SUBJECT: Addendum No. 4

REFERENCE: Invitation To Bid (ITB) for the Runway 4-22 Shoulders Pavement Rehabilitation & Lighting Upgrades at William P. Hobby Airport (HOU); Solicitation No. H06-RSPRLU-2025-006; Project No. 1057

MATCHLINE, SEE SHEET CD105

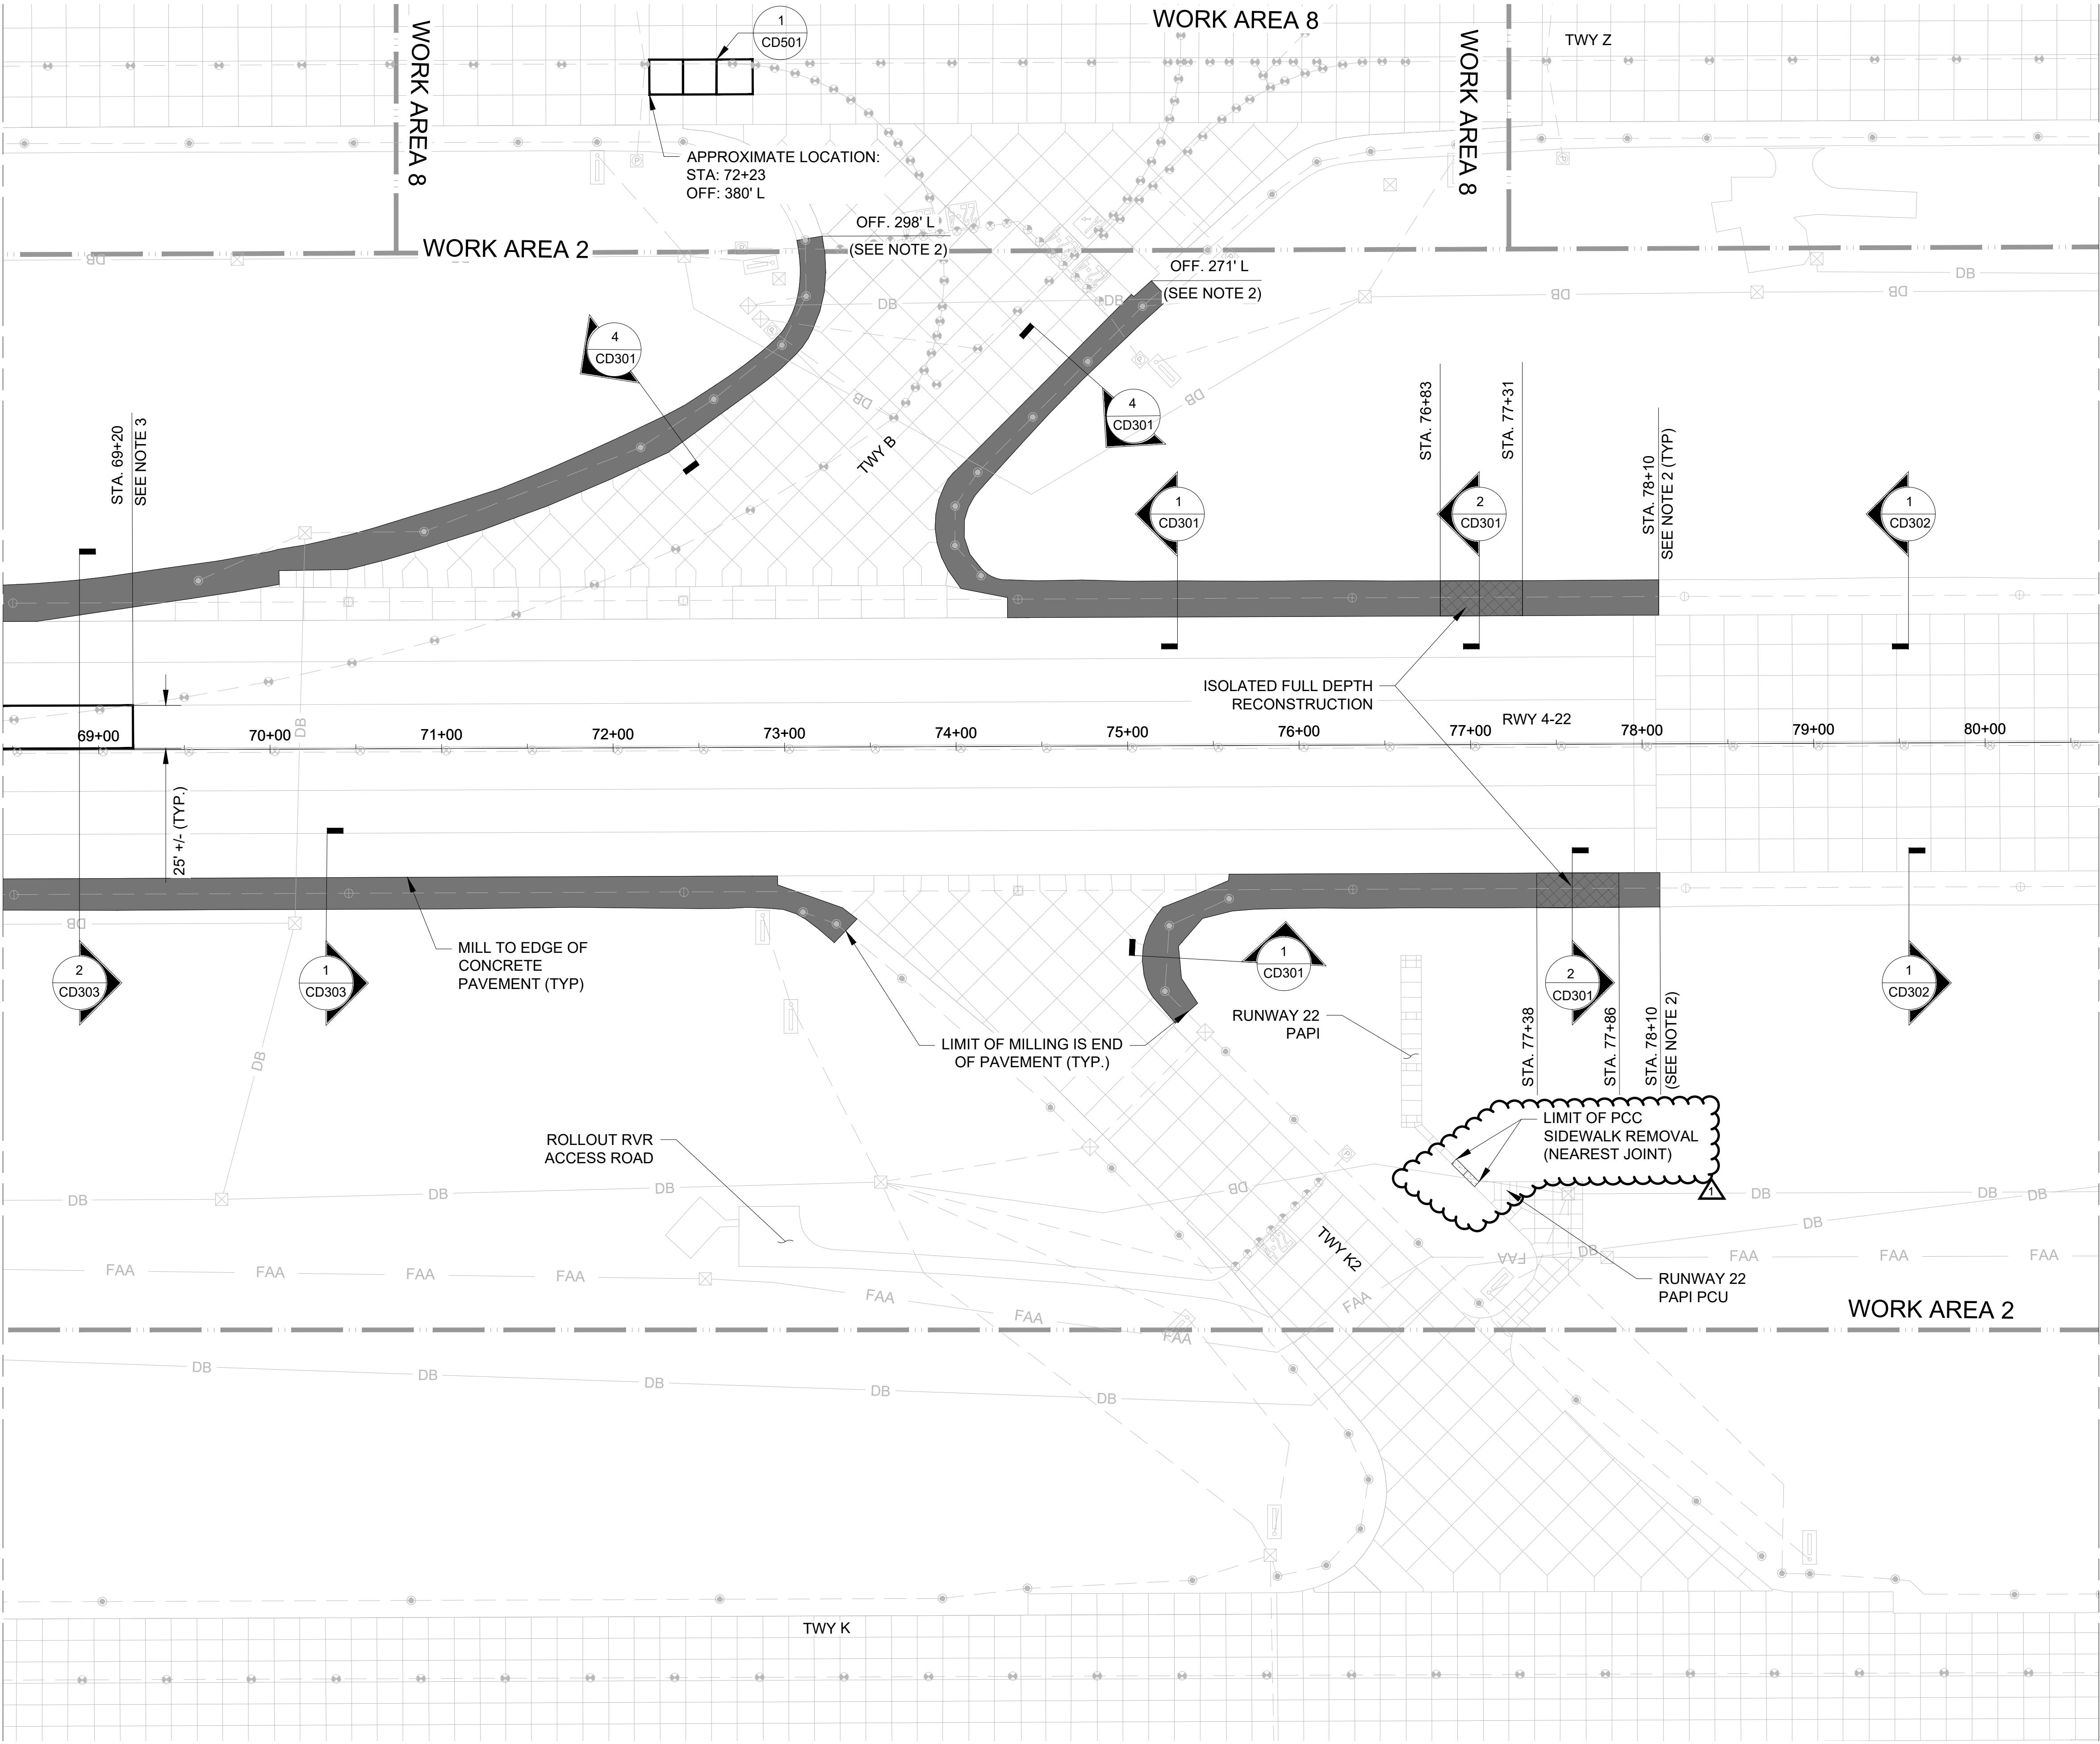
9. **Question:** On TWY R in the meeting power point it is color coded to show just crack sealing. On drawing CD105 it shows that the entirety of TWY R to be PCC Slab Removal. Please confirm on correct approach.

Response: Please reference Sheets CD105 and CP105 for work to be performed on TWY R.

EP107

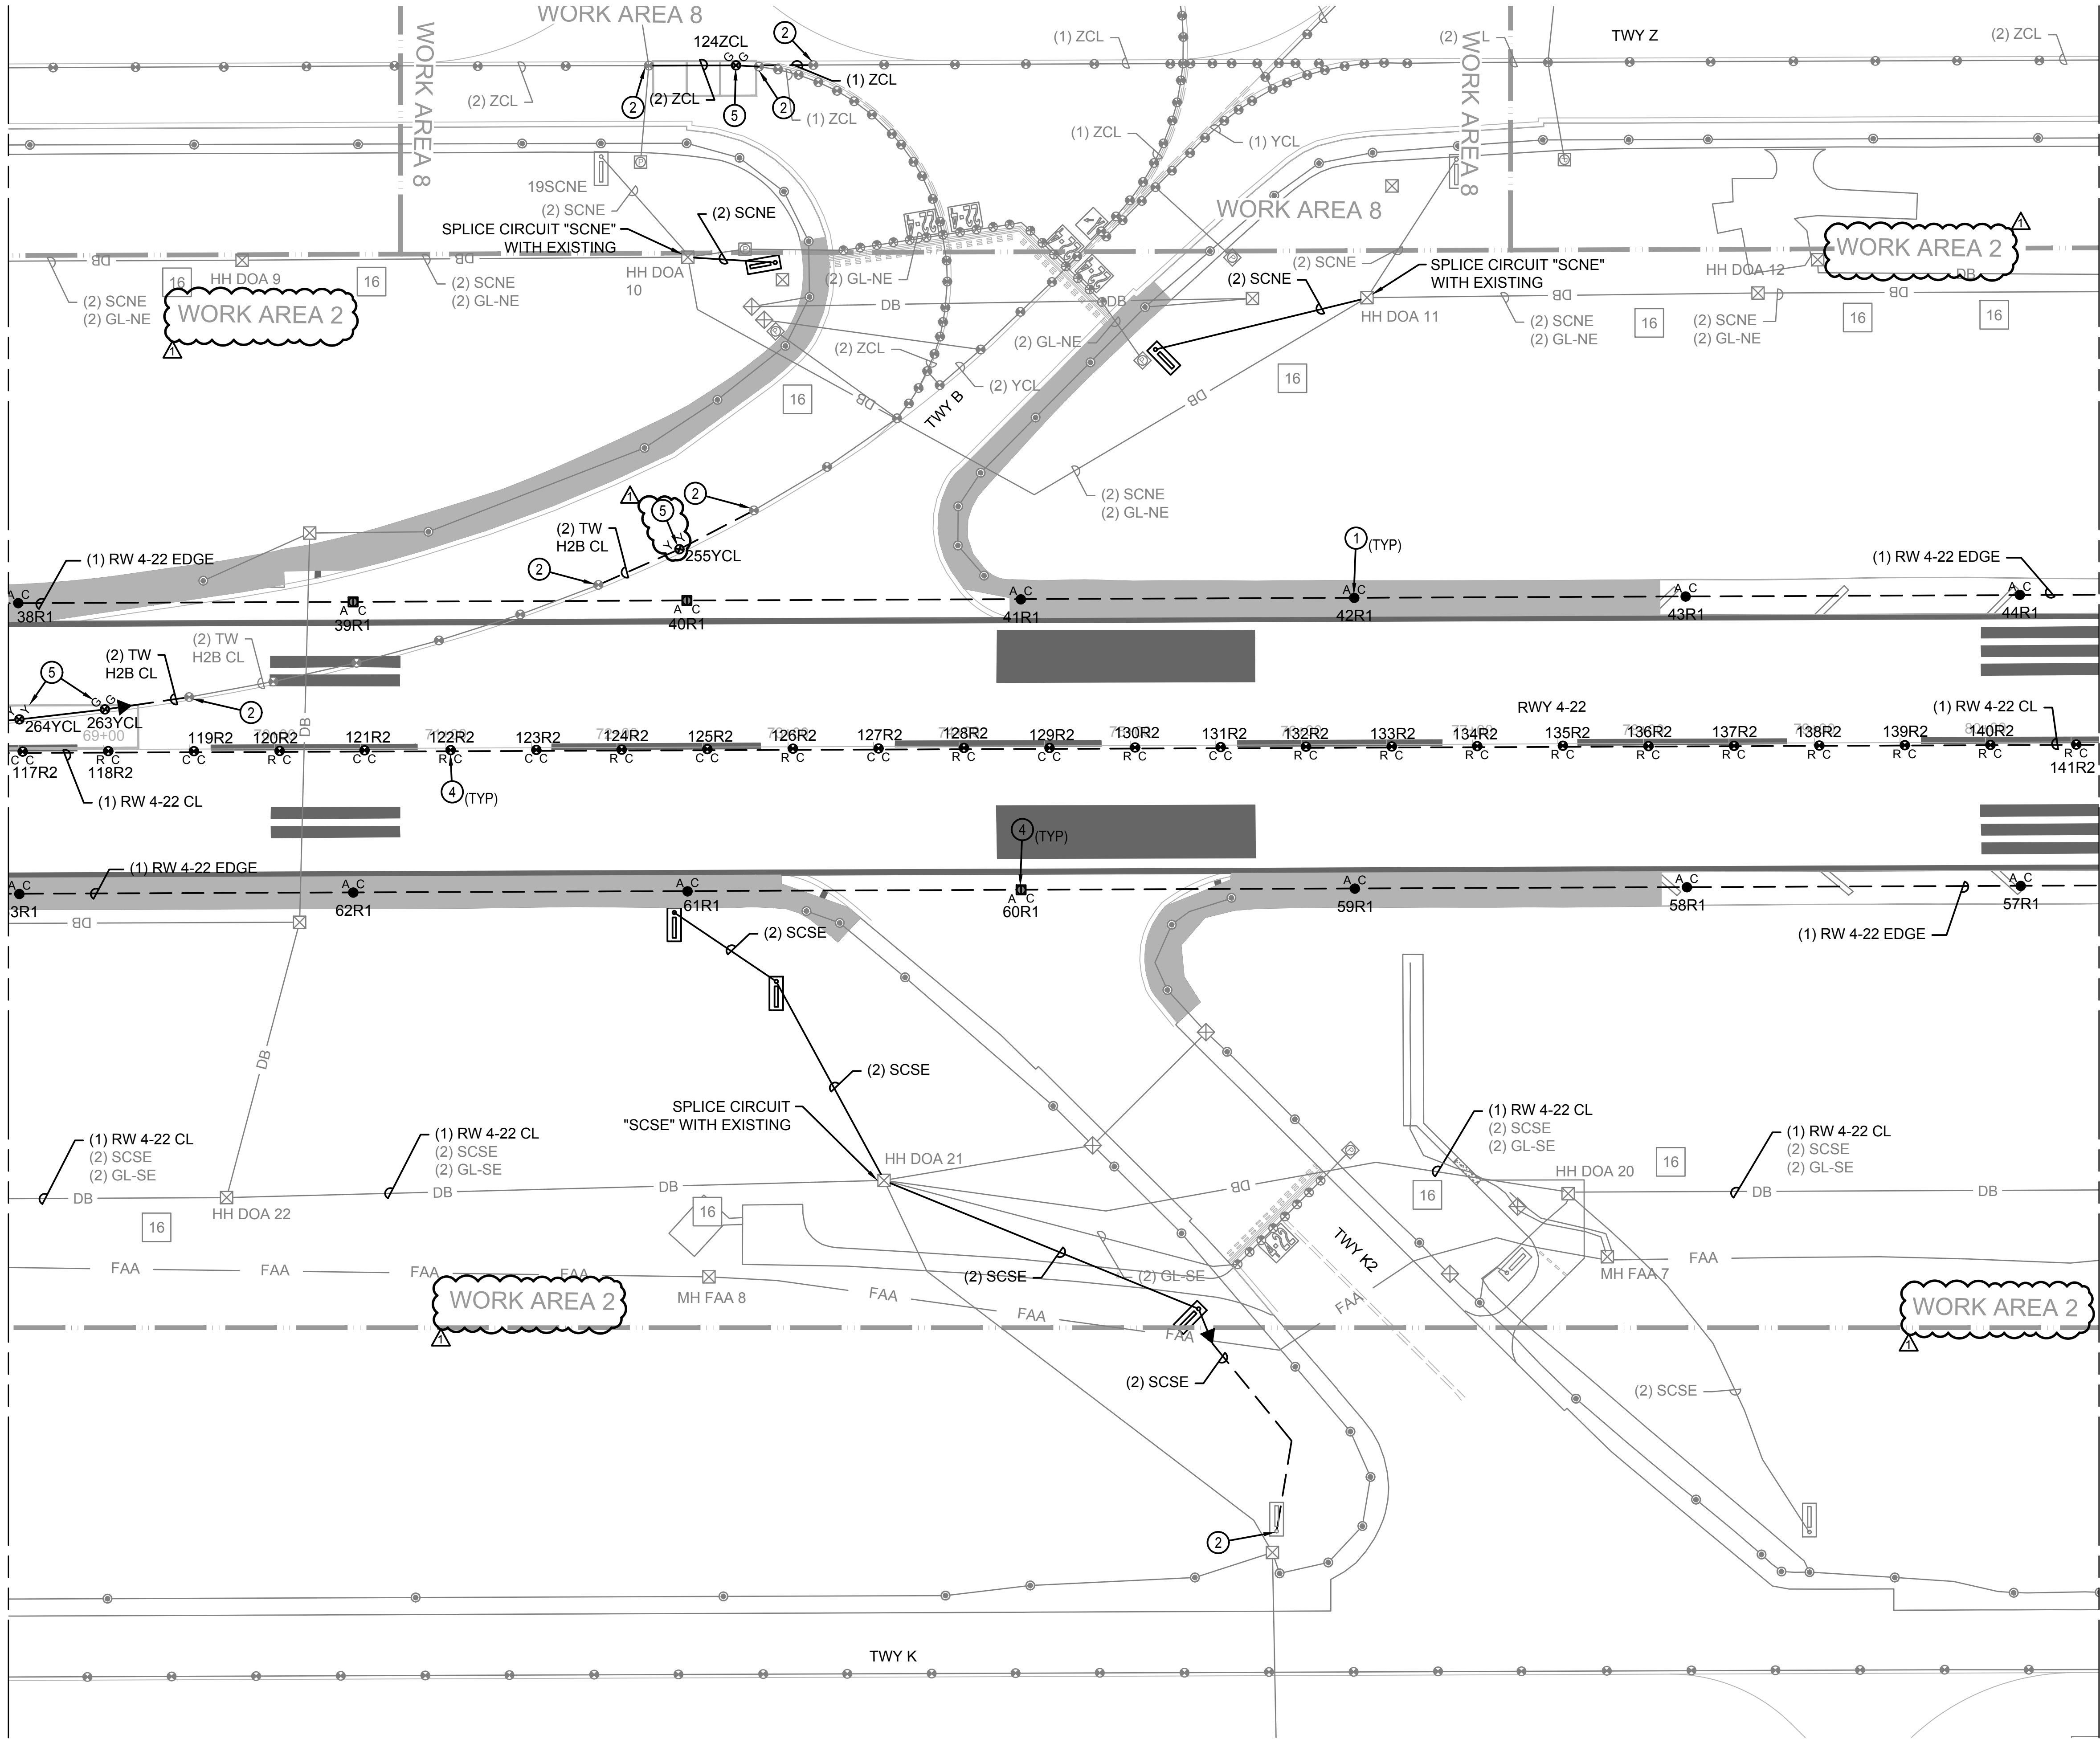
51. **Question:** On TW B and TW Y on the electrical install sheets there are 1ea TW Centerline lights that appears to be new in existing full-strength pavement. Please provide note indicating if this is a new light, new base can or salvaged and/or existing. Please provide pay item if applicable pay item is not present.

Response: The intent of this work is for the existing light to be salvaged and protected during the replacement of the pavement panel, then re-installed on a new L-868B base can. See updated Sheets EP106 and EP107 included in this addendum where keyed note 5 has been added to each of those taxiway centerline lights to clarify. Additionally, see revisions to Bid Form included in this addendum where the language for pay item L-125-5.2 has been updated to better reflect the scope.
